Assessment of LCLS-II Module Production at FNAL

Version 2.0 September 19, 2017

O. Napoly

XFEL lowest performing cavities per modules

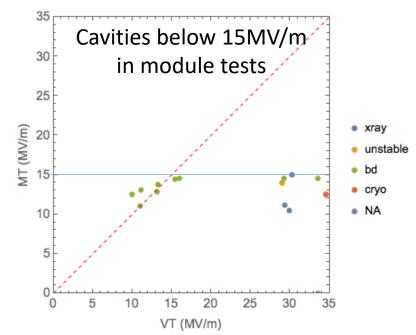
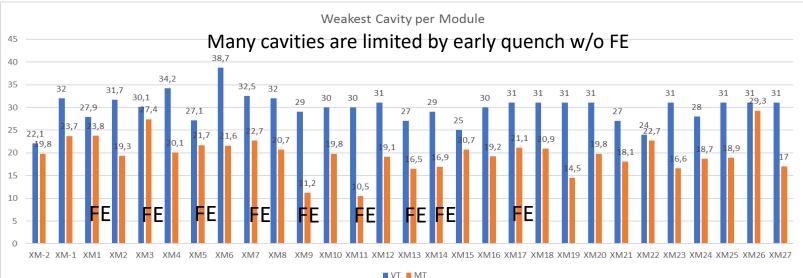
- FE limited usable gradients, represented in both figures, are more in the range of 19 MV/ or higher.
- Very few cavities are limited by FE below 15 MV/m, like in XM9 and XM11.

XFEL XM40 Module Test X-Rays Measurement

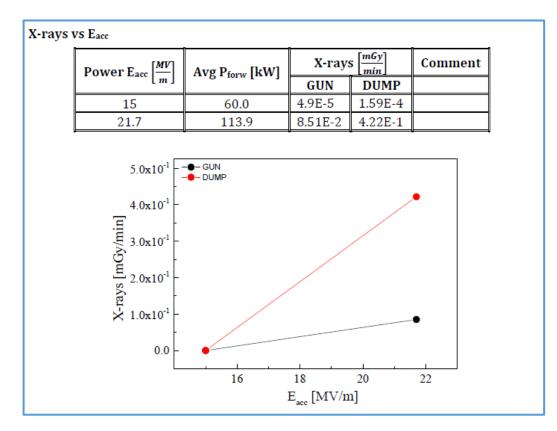
GUN	DUMP		
MV/m	mGy/min	mGy/min		
15	4,90E-05	1,59E-04		
21,7	8,51E-02	4,22E-01		
	2,07	1,96	(MV/m)/deca	ade

XFEL XM46 Module Test X-Rays Measurement

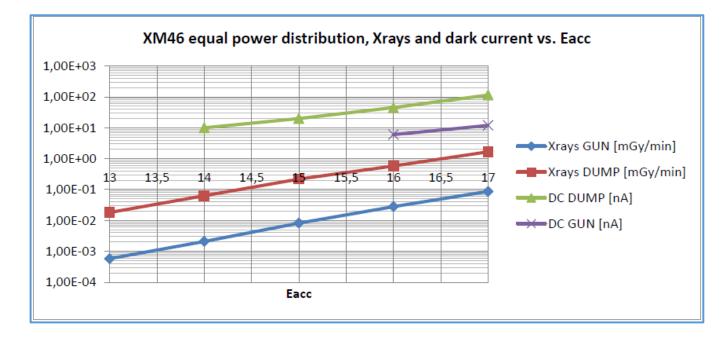
"XM46 is one of our dark current 'light bulbs' " (N. Walker)

GUN	DUMP		
MV/m	mGy/min	mGy/min		
13	5,80E-04	8,70E-02		
17	1,80E-02	1,68E+00		
	2,68	3,11	(MV/m)/dec	ade
